RAILWAY (METROLINK-ESTUARY TO CHARLEMONT VIA DUBLIN AIRPORT)
ORDER 2022

RE: SUBMISSION ON THE METROLINK RAILWAY ORDER APPLICATION IN
RELATION TO AIRSIDE RETAIL PARK, SWORDS, CO. DUBLIN

AN BORD PLEANÁLA REFERENCE: NA29N.314724

CONSTRUCTION TRAFFIC MANAGEMENT PLAN TECHNICAL NOTE – 23/11/2022

Figure 4: Extract from drawing 'Railway Works MetroLink – Property Details Airside Shopping Centre (Sheet 1 of 2)'

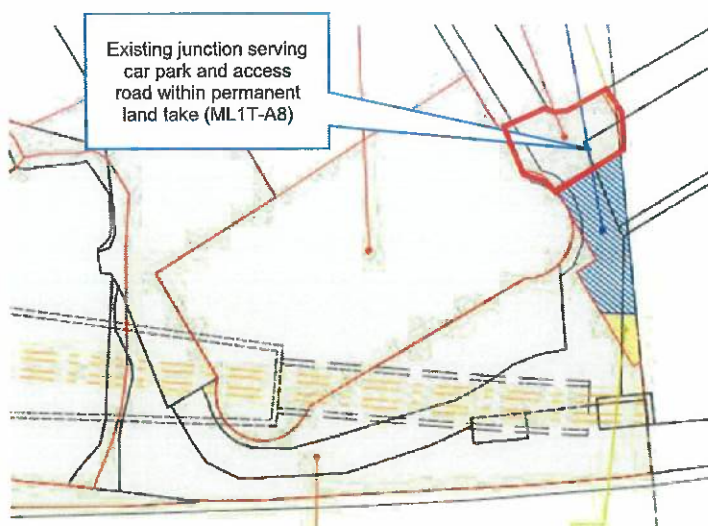
The Order application also includes the permanent acquisition of an area in front of Unit 1 (Land Take Reference No. ML1T-A8), comprising of the northern end of the main access road to this portion of the Retail Park from Nevinstown Land. This area is indicated on Figure 2 above and in greater detail in Figure 4 below.

Our clients have concerns in relation to the permanent acquisition of this area of land (ML1T-A8). It is not clear why it is proposed to acquire this area permanently and respectfully requested that this should be omitted from the permanent land take in any approved Railway Order. This area of land (illustrated in Figure 4 above) poses a critical part of the existing infrastructure of the retail park as it is located on the main access route into this area of the retail park and serves a significant existing car park at this location.

This parcel of land should remain in the ownership and control of the owners of Phase 1, Airside Retail Park i.e. IPUT and Irish Life Assurance plc. It is considered that this area of land is not required for the operation of the Metro and that this matter is best addressed extending the right of way/wayleave along the access road into and through this parcel of land leading to the proposed Fosterstown station.

Figure 5: Extract from drawing 'Railway Works MetroLink – Property Details Airside Shopping Centre (Sheet 1 of 2)'

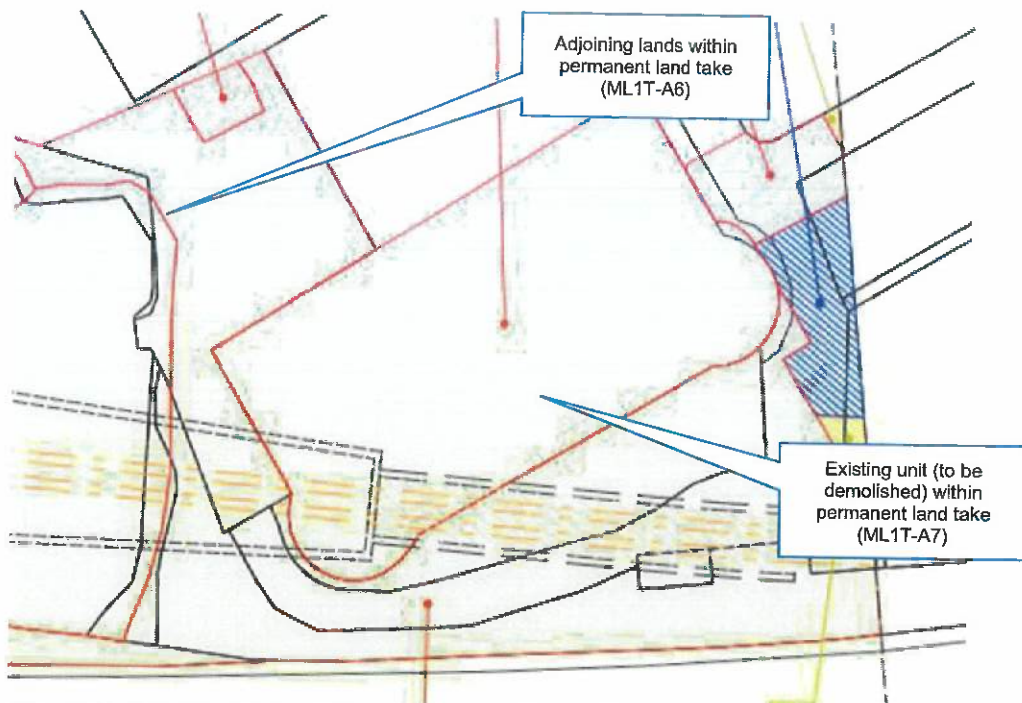
Secondly, it is noted that it is proposed to acquire a portion of land to the rear of Unit 1 and Unit 2 (ML1T-A6) and a portion of the land resulting from the demolition of Unit 1 (ML1T-A7) for landscaping purposes as part of the permanent land take for the project (see Figure 5 below). It is understood that this area of land is not required for the permanent and ongoing operation of the MetroLink project post construction. Therefore, it is also requested that it is agreed that this area of land shall be acquired on a temporary basis only if necessary and returned after the completion of construction to its current owners IPUT and Irish Life Assurance plc. It is important for the ongoing operation management and maintenance of the retail park that this area remains permanently in the ownership of our clients, the owners of Phase 1 of Airside Retail Park.

Figure 6: Approximate extent of lands which should be returned to our clients post-construction (in red) – extract from route layout plan

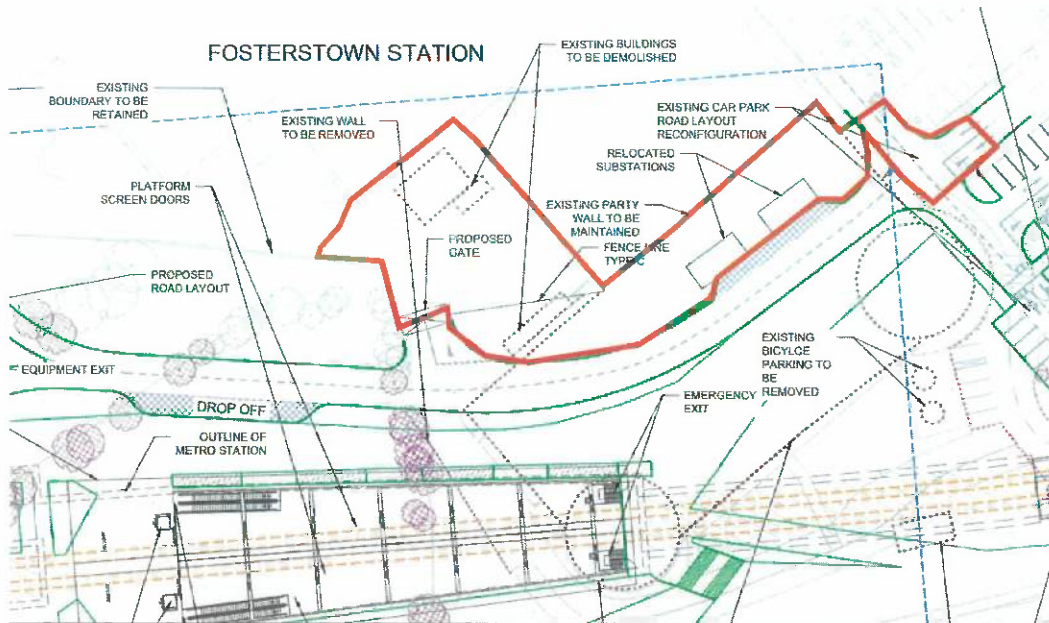
The extent of lands which are currently shown for permanent acquisition / land take, but which it is submitted should be re-designated as temporary land-take only are indicated approximately on Figure 6 and 7 below.

Figure 8: Potential alternate route for wayleave Ref. No. ML1U-W2 in red dashed line

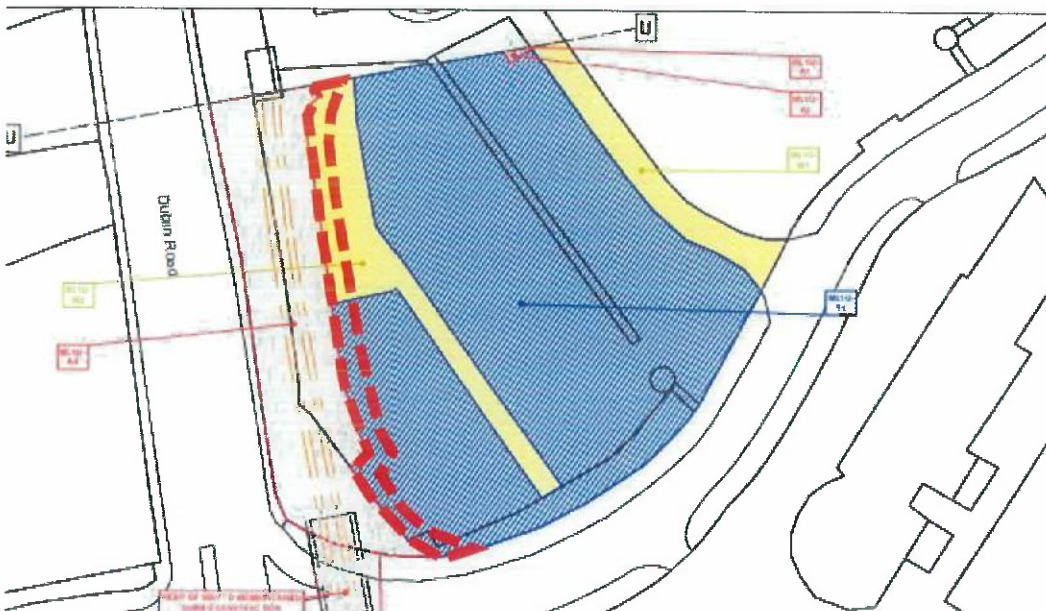
Additionally, as noted the further proposed right of way / wayleave (which it is understood is intended to facilitate below-ground services and periodic access for works) proposed through the centre of the existing car park adjacent to Unit 1 (ML1U-W2) will effectively bisect this area of car parking instead of following the boundary of the existing car park. It is requested that this alignment of wayleaves/right of way is realigned parallel to the metro alignment as proposed in order to minimise it's potential impact for future disruption to the carpark. This option should be fully investigated by TII.

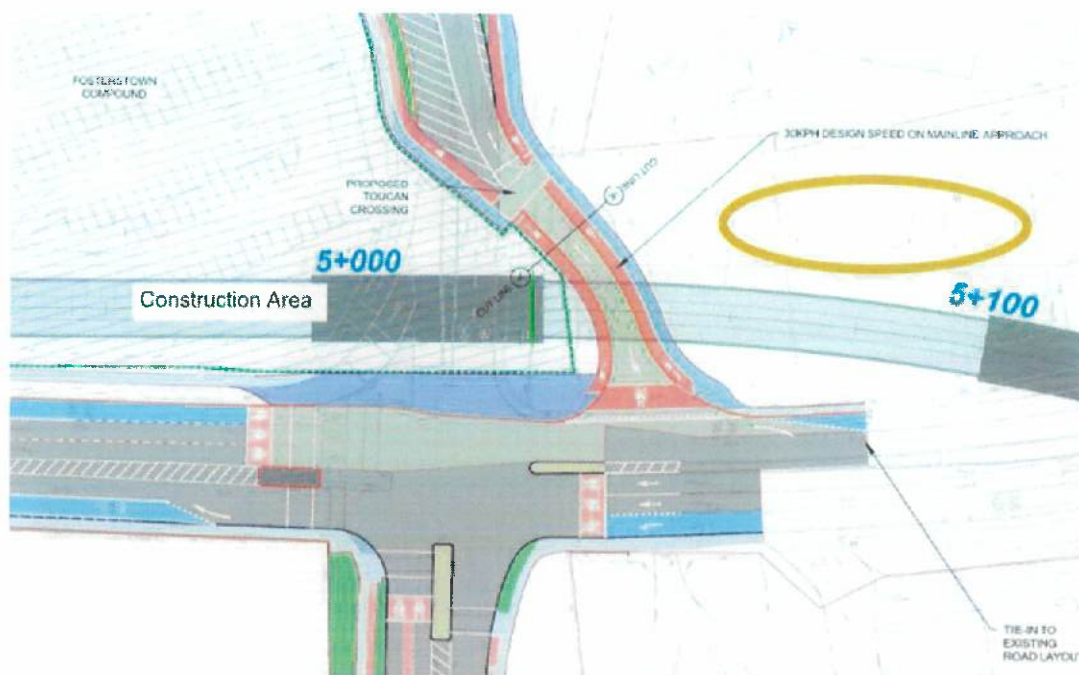
Residual impacts are described in the report as impacts which cannot be further reduced or remediated. Severe residual traffic impacts of this magnitude for an extended period would be of concern, as they could impact on the operation of Airside Retail Park, which is dependent on vehicular access for trade.

Further reduction of impacts or remedial actions are considered feasible. Potential solutions that should be investigated include:

- i. Split phase 1 of the Nevinstown Signalised Junction Traffic Management Plan into several phases, allowing the cut and cover section of the Nevinstown Lane crossing to be completed in two or more parts, while maintaining two-way traffic between Nevinstown Lane and R132 Dublin Road.
- ii. Use the area for the Nevinstown Lane Construction Compound (circled below) to provide a two-way access road and a full movement three-arm signalised junction with the R132 Dublin Road, i.e. creating a staggered crossroads.
- iii. Reduce the size of the Fosterstown Compound to provide a two-way access road and a full movement three-arm signalised junction with the R132 Dublin Road.

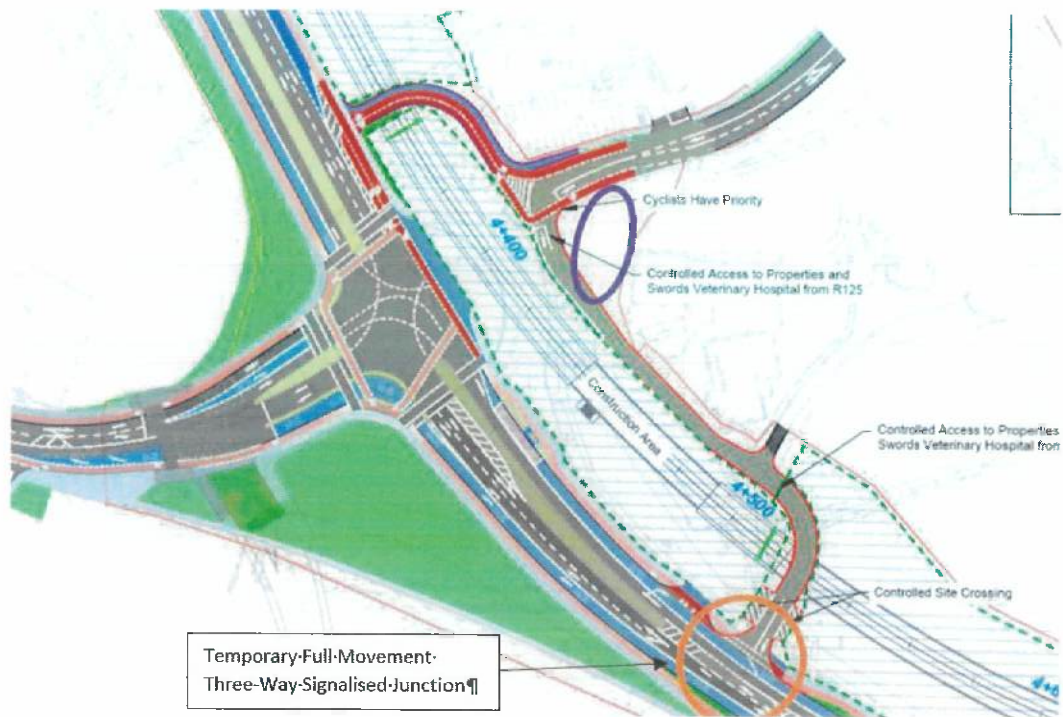
Severe residual traffic impacts of this magnitude for an extended period would be of concern, as they could impact on the operation of Airside Retail Park, which is dependent on vehicular access for trade.

Further reduction in traffic impacts or remedial actions are considered achievable. Potential solutions which should be investigated including:

- a. Split Phase 2 of the Pinnock Hill Junction traffic management plan into several phases, allowing the cut and cover section of the R125 crossing to be completed in two or more parts. An additional phase could be added which provides a temporary full access signalised junction where the left in and left out is currently proposed while the cut and fill across the R125 south arm is constructed. The area within the red line boundary circled in purple in the image below could be used to connect the temporary two-way access to the R125. A second additional phase could reinstate the permanent signalised junction layout while the remaining cut and cover or cut and retain sections of the metro are constructed.

Figure 5-3: Construction Sequencing in the North section

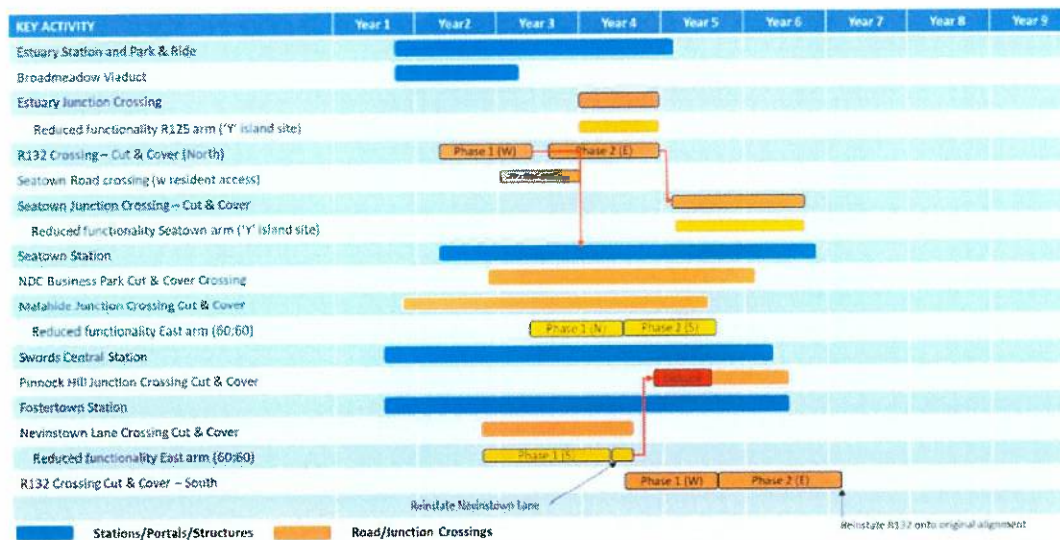
It is crucial to Airside Retail Park accessibility that the construction activities at Nevinstown Lane (Airside Junction) and Pinnock Hill Lane Junction do not overlap as per the proposed construction sequence outlined in the Scheme Traffic Management Plan, Figure 5-3, which is copied below.

Section 5.1.1 and section 5.1.2 of the Scheme Traffic Management Plan describes that the R132 Connectivity Project and BusConnects should be completed before the MetroLink construction phases commence. Any delay to these projects should be coordinated with MetroLink as an overlap in construction activities and the associated traffic management could result in gridlock on the surrounding road network and at Airside Retail Park.
